**Work Order ID 78244**

Item Name: Crosstube Fwd

<b>DART AEROSPACE LTD</b>		<b>Work Order:</b> 78244
<b>Description:</b> Crosstube High Fwd (205/212/412)		<b>Part Number:</b> D212-664-101
<b>Inspection Dwg:</b> D212-664-141 <b>Rev:</b> D		<b>Page 1 of 1</b>

DRAWING NO. D212-664-141	TITLE XTUBE ASSY (205/212/412 HI FWD)	REV. D	<b>DART AEROSPACE LTD ENGINEERING ORDER</b>		D.E.O. NO. D212-664-141-D-1	SHEET NO. SHEET 1 OF 2	SCALE NTS
DRAWN	CHECKED	MP	MFG. APPR.	RE	APPROVED	MP	DE APPR.
DATE 11.04.07	DATE 11.07.11		DATE 11.04.12		DATE 11/04/12		DATE 11.04.12

**D212-664-141/-141B  
ASSEMBLY DETAIL**

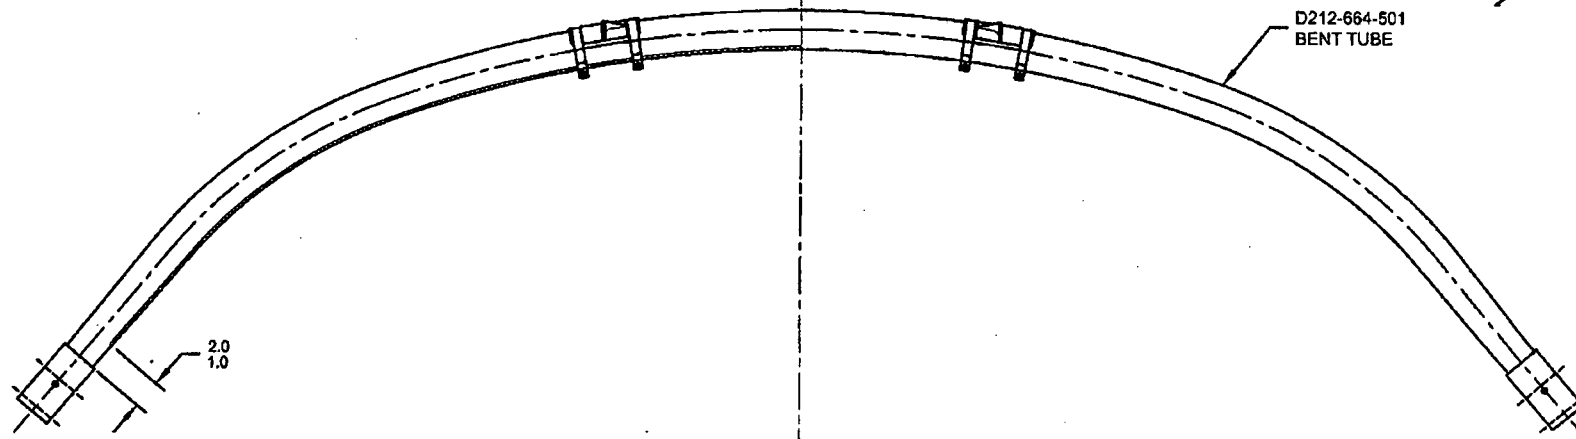
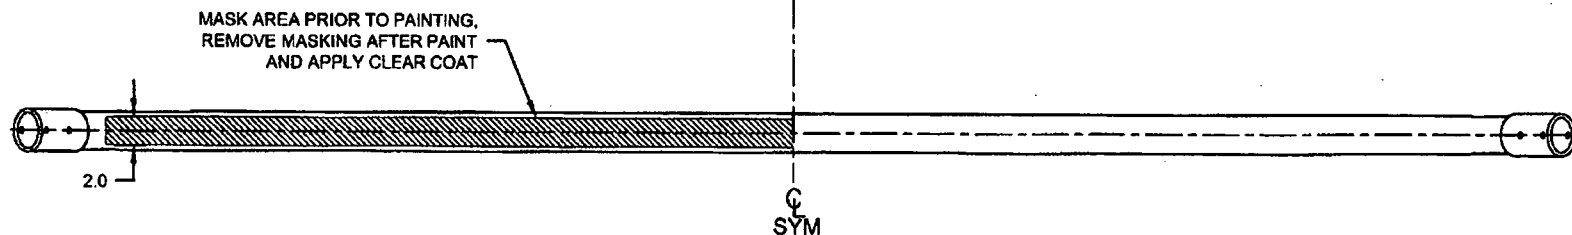
**PURPOSE:**

ADD AN INSPECTION WINDOW TO UNDERSIDE OF CROSSTUBE.

**CHANGE:**

**NOTES 2 OF SHEET 1 IS AMENDED AS FOLLOWS:**

- 2) FINISH: CHEMICAL CONVERSION COAT PER DART QSI 005 4.1  
PRIME INSIDE AND OUTSIDE PER DART QSI 005 4.2  
MASK UNDERSIDE OF CROSSTUBE AS SHOWN (HATCHED AREA) AND  
PAINT OUTSIDE PER DART QSI 005 4.2  
REMOVE MASKING AND APPLY CLEAR COAT

- 2) FINISH: CHEMICAL CONVERSION COAT PER DART QSI 005 4.1  
PRIME INSIDE AND OUTSIDE PER DART QSI 005 4.2  
PAINT OUTSIDE PER DART QSI 005 4.2
